A.T and R.E Arnold
1 Table Cape Road
Wynyard, Tasmania, 7325

**RE: Pre-Hearing Representation – Representation 12
Waratah-Wynyard draft Local Provisions Schedule (LPS)**

Further to our original representation regarding the Proposed Rural Zone transition north of River Road Wynyard and in reply to the Planning Authority Response in the Draft Local Provisions Schedule – Section 35 (F) Report for Waratah-Wynyard, we would like to provide further representation before the hearing scheduled 20th October 2022.

Figure 3: Amended request to substitute a SPP from Rural Zone to Agriculture Zone

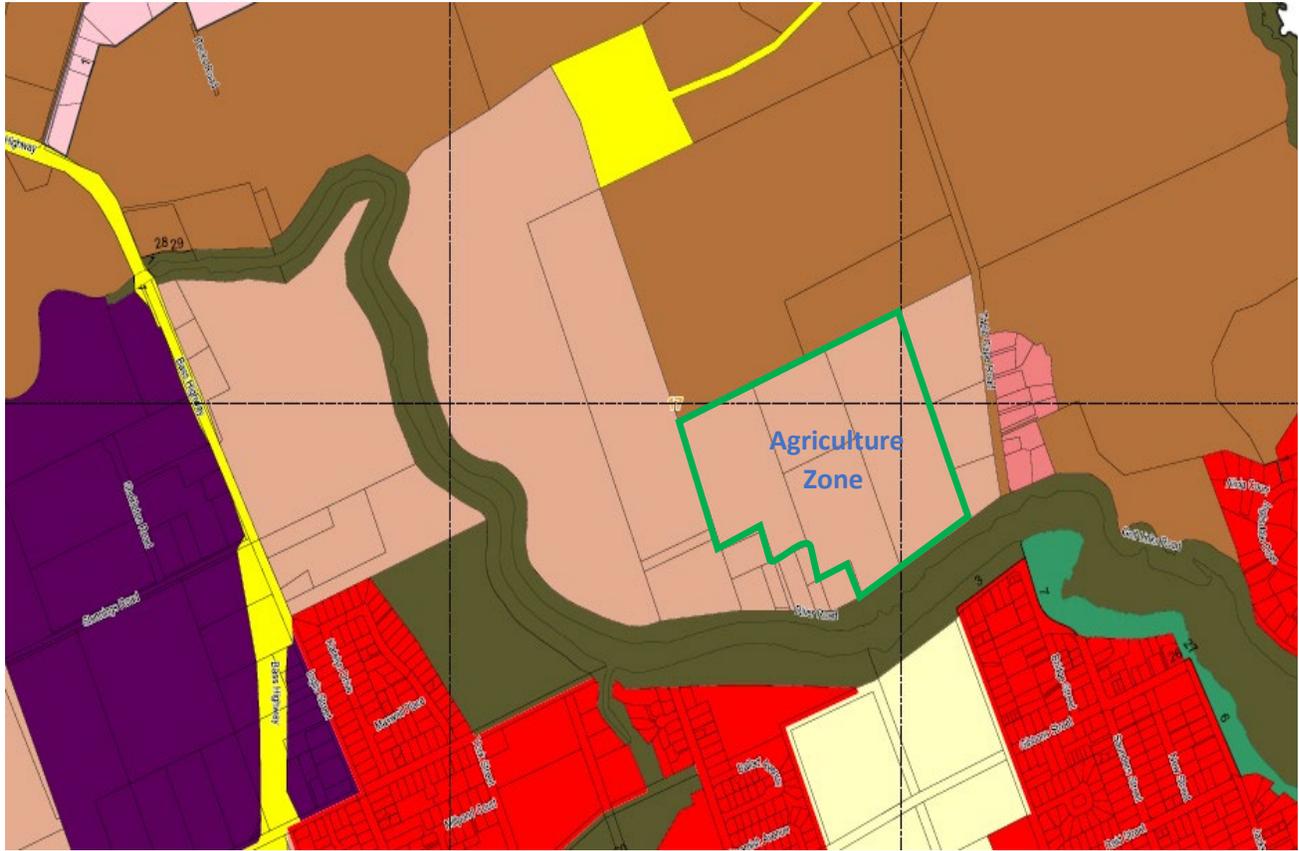
from the Agricultural land to the north; and does not alter any information provided in our original representation regarding the Agricultural and Rural Zone Decision Rules and Guidelines.

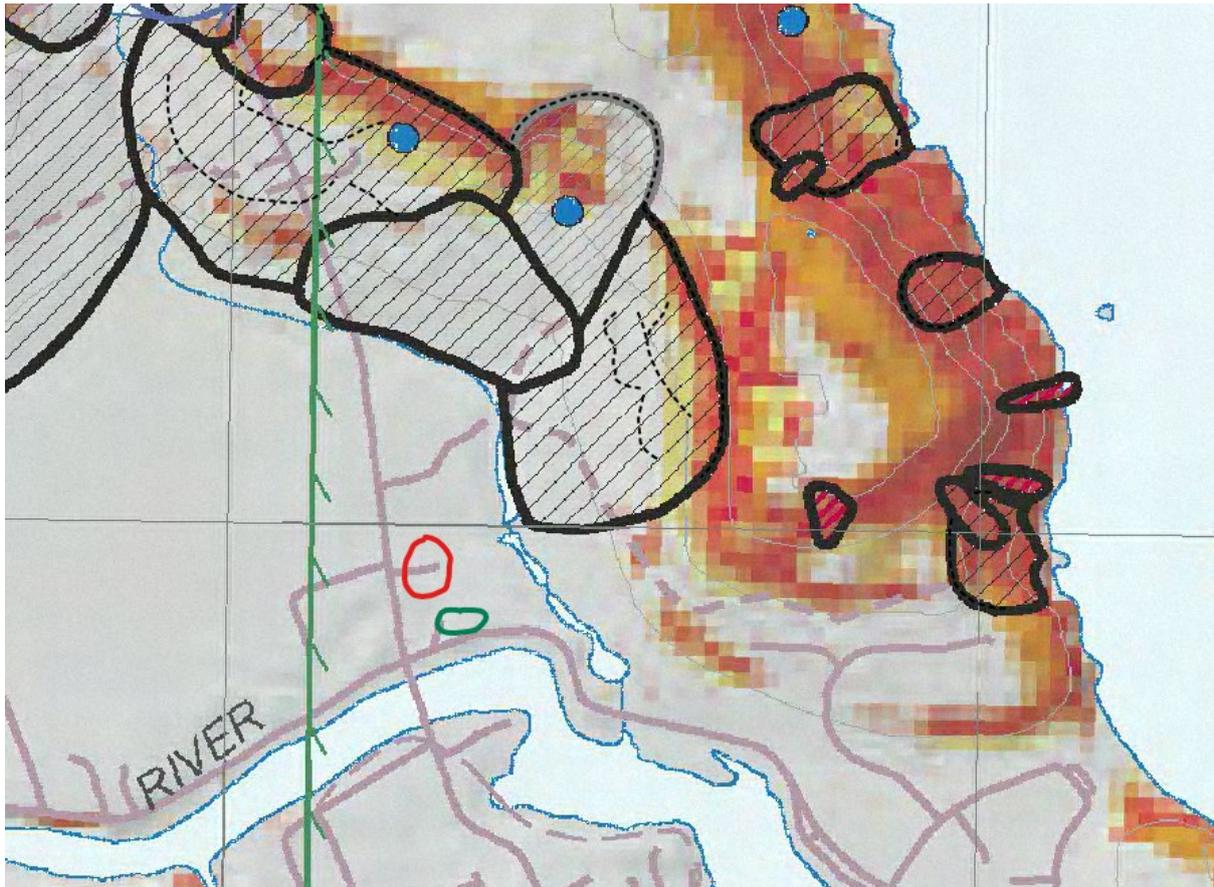
Yes all existing agricultural land should be valued and protected to be a source of sustainability and food production for future generations.

River Rd and River Rd East currently are owned by the same land owner – not good enough. Landslide is the main reason River Road East is not desirable.

Growth front figure 3.12

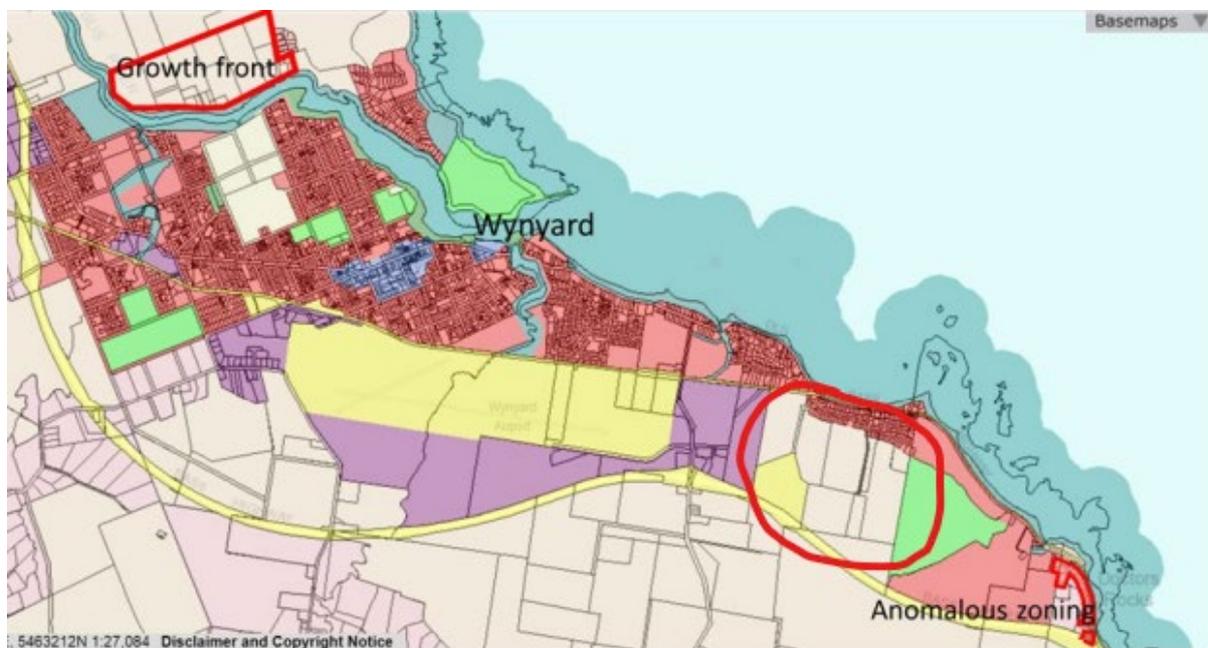
The natural beauty of this area needs to be preserved, not cut up into blocks and developed. How many towns in Australia has as much beauty as Wynyard so close the centre of town? Not many at all!

River Road Draft Outline Development Plan

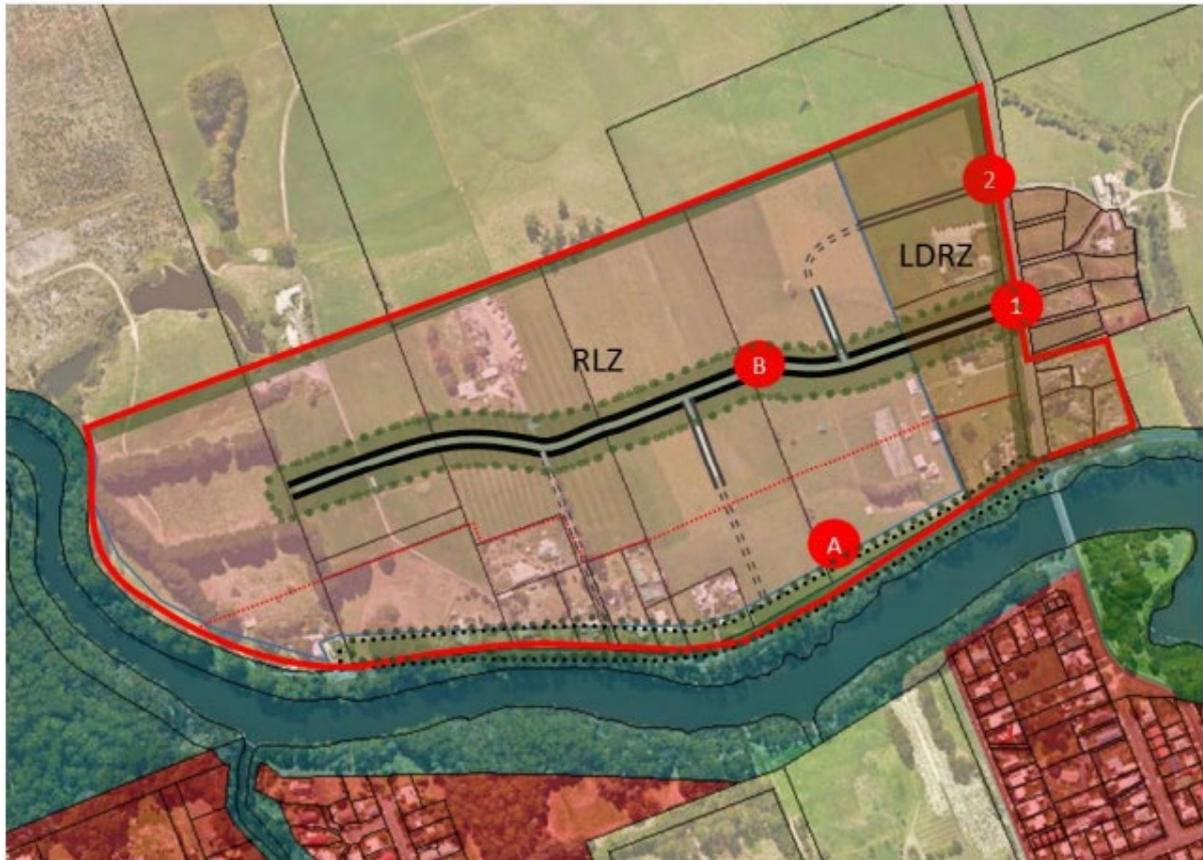
Based on figure 3.28 – this will definitely mean the trucks will go down access road 1. Would be nice to see this many people utilising the river track now as depicted in this picture, but never see it now so doubt it will change.
